**GENOA CHARTER TOWNSHIP  
PLANNING COMMISSION PUBLIC HEARING  
TUESDAY, OCTOBER 11, 2016  
6:30 P.M.  
AGENDA**

<b>Attention:</b>	Kelly Van Marter, AICP Planning Director and Assistant Township Manager
<b>Subject:</b>	Genoa Plaza – Site Plan Review #2
<b>Location:</b>	Grand Oaks Drive – vacant parcel at the northwest corner of Grand Oaks and Latson Road
<b>Zoning:</b>	NR-PUD Non-Residential Planned Unit Development District

**Re: Genoa Plaza  
Site Plan Review**

PROJECT	PREPARED FOR	TITLE
GENOA PLAZA	USA 2 GO	SITE PLAN
DATE	9-21-16	
REVISION PER		
NO	CH	BY
1	CH	CD
DESIGNED BY: TD		
DRAWN BY: CD		
CHECKED BY:		
SCALE 1" = 30'		
JOB NO. 16-243		
DATE 08/22/16		
SHEET NO.		
C3

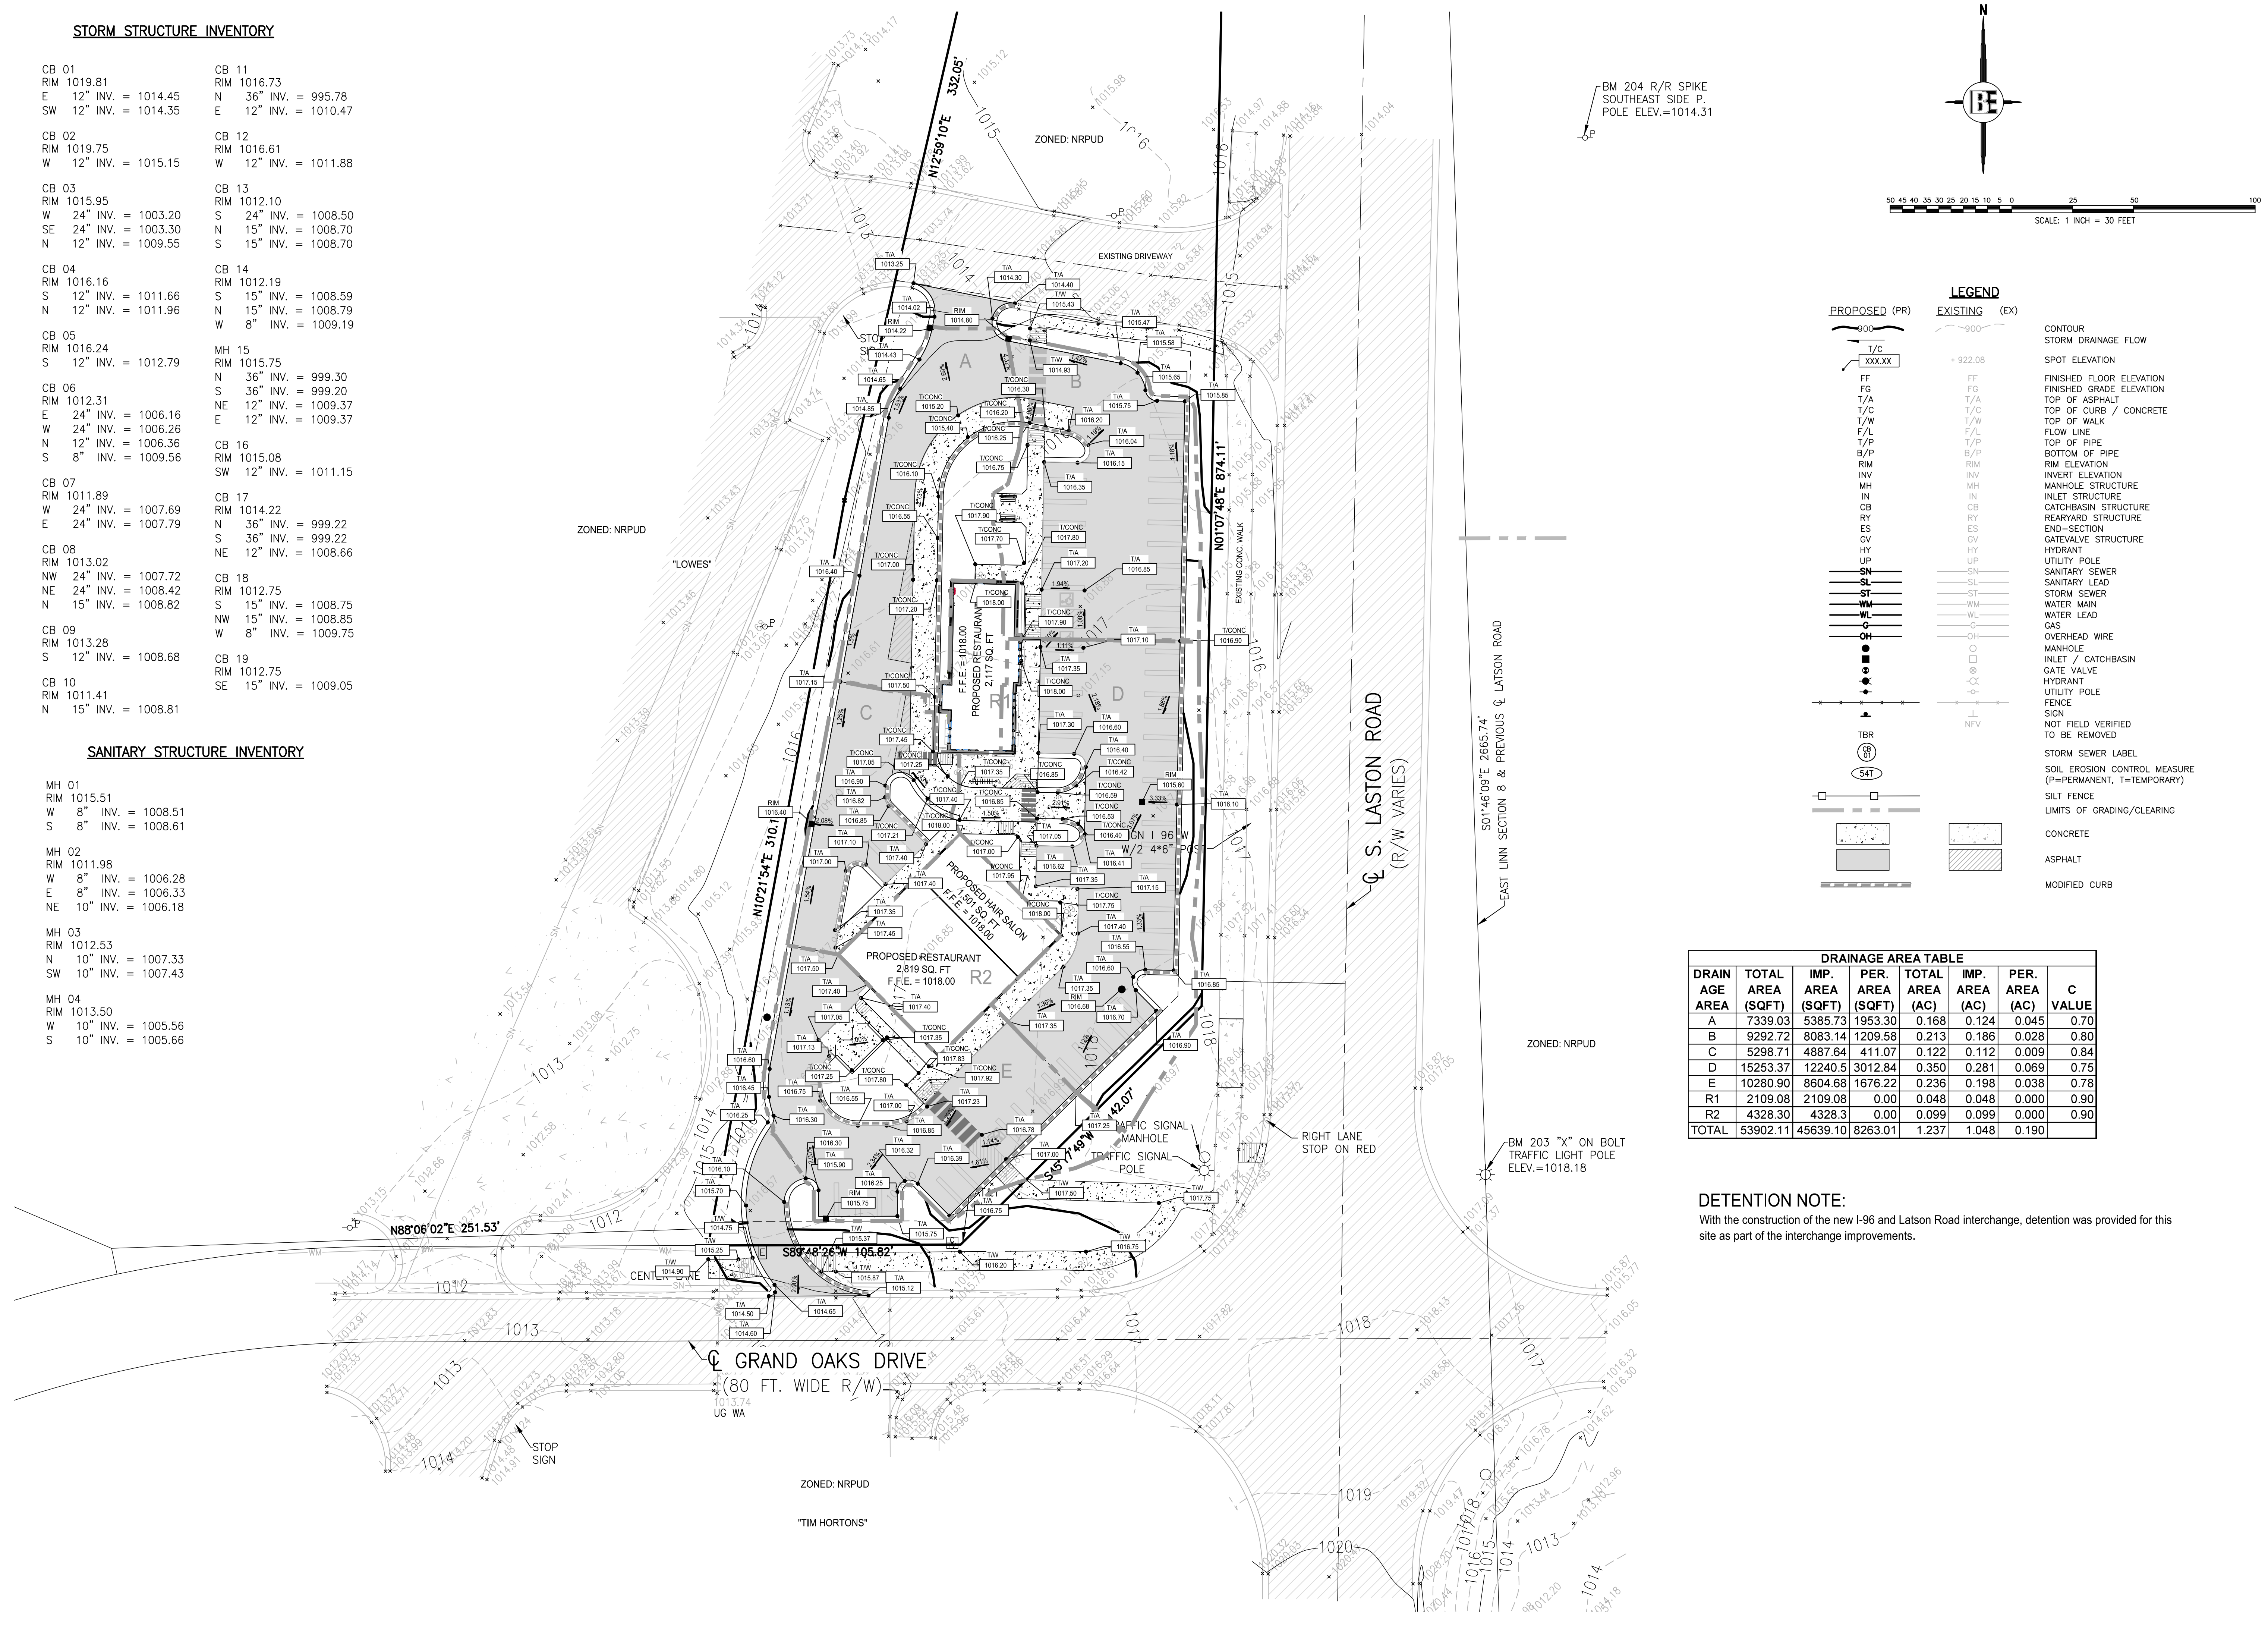
The applicant has confirmed the lot area as 1.43 acres, which is consistent with the Impact Assessment. However, Sheet C3 refers to it as a 2.31-acre site.

**UTILITY PLAN**

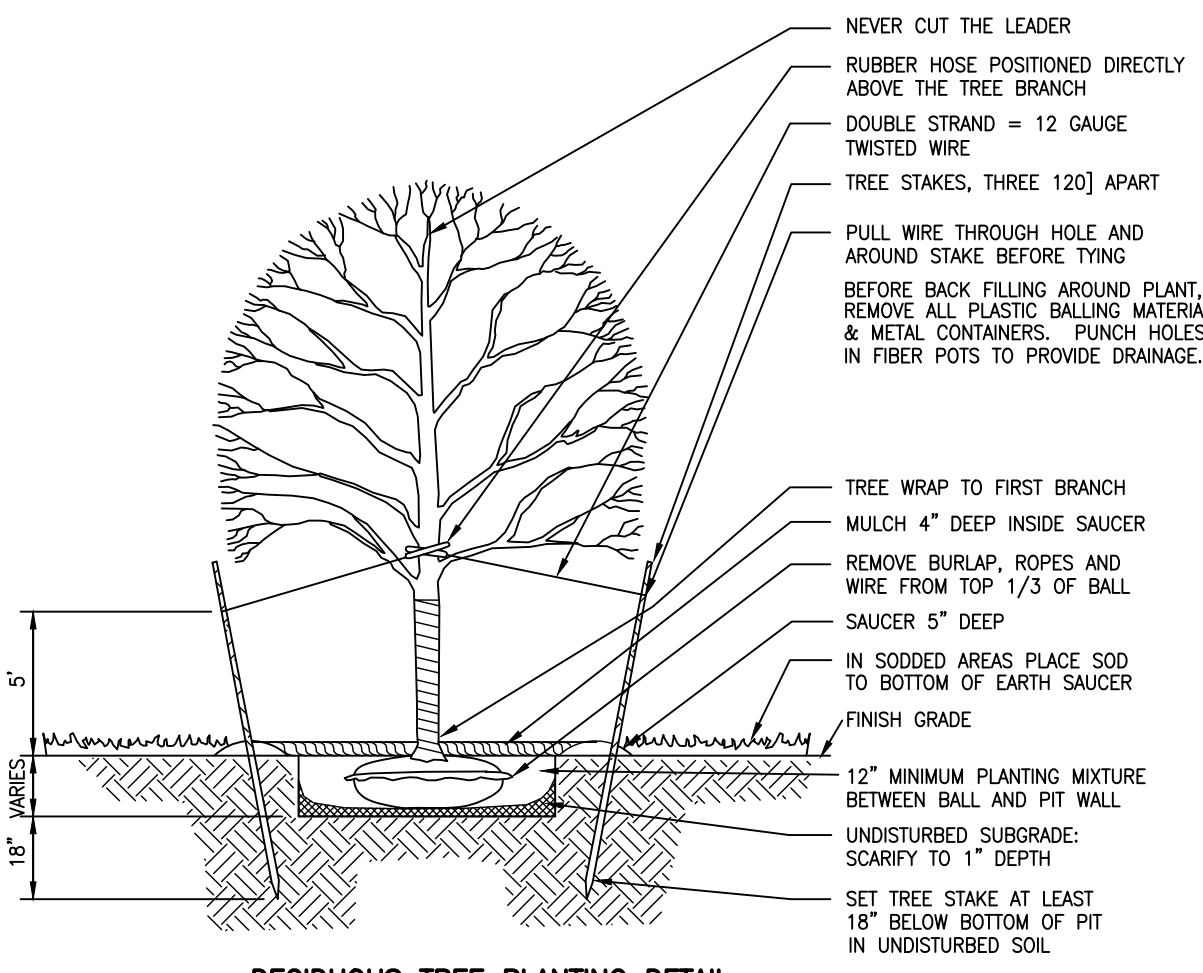
4. An additional fire hydrant must be installed on the front (Latson Rd.) side of the structure at the drive-thru lane exit between the two buildings, near reference P09. The existing hydrants provided on the Utility plan are located at the rear area not on the property and are not conducive for fire department operations. **(Provided on Utility Plan in appropriate location)**

C6

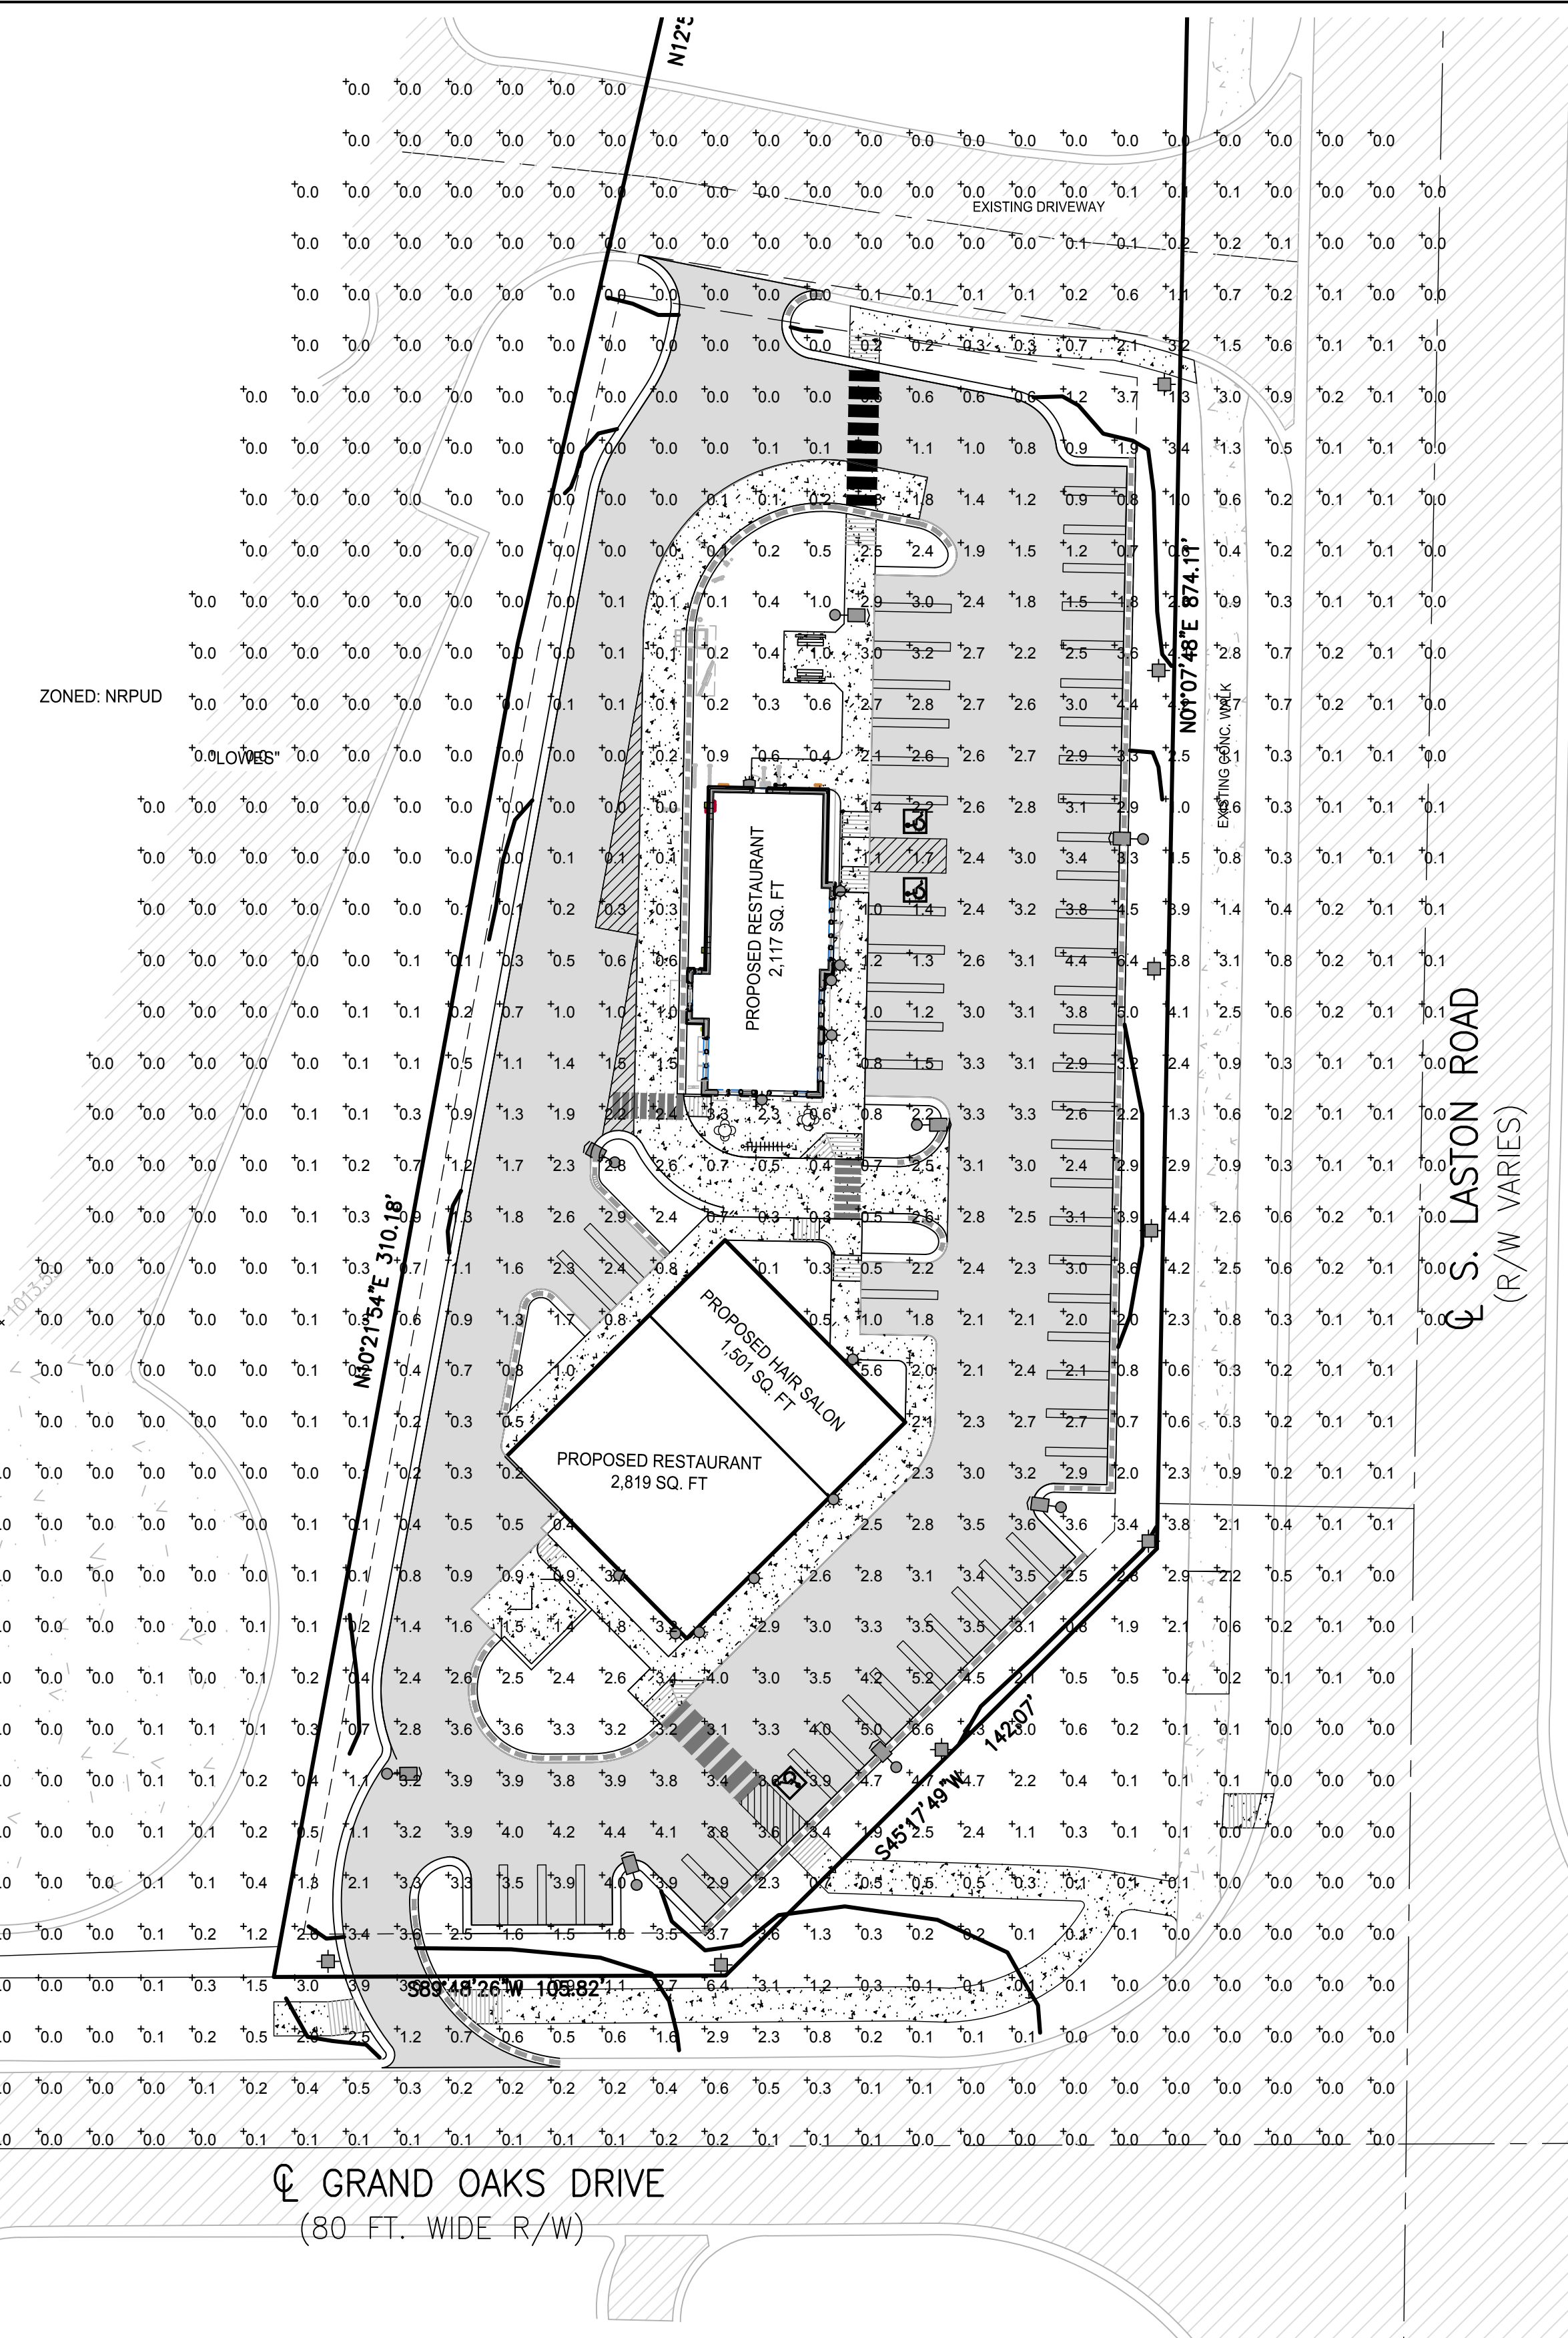
Lastly, there are two minor discrepancies between the landscape plan and table of plantings that need to be corrected for the number of Littleleaf Linden (9 versus 7) and Mount Airy Fothergilla (42 versus 38).
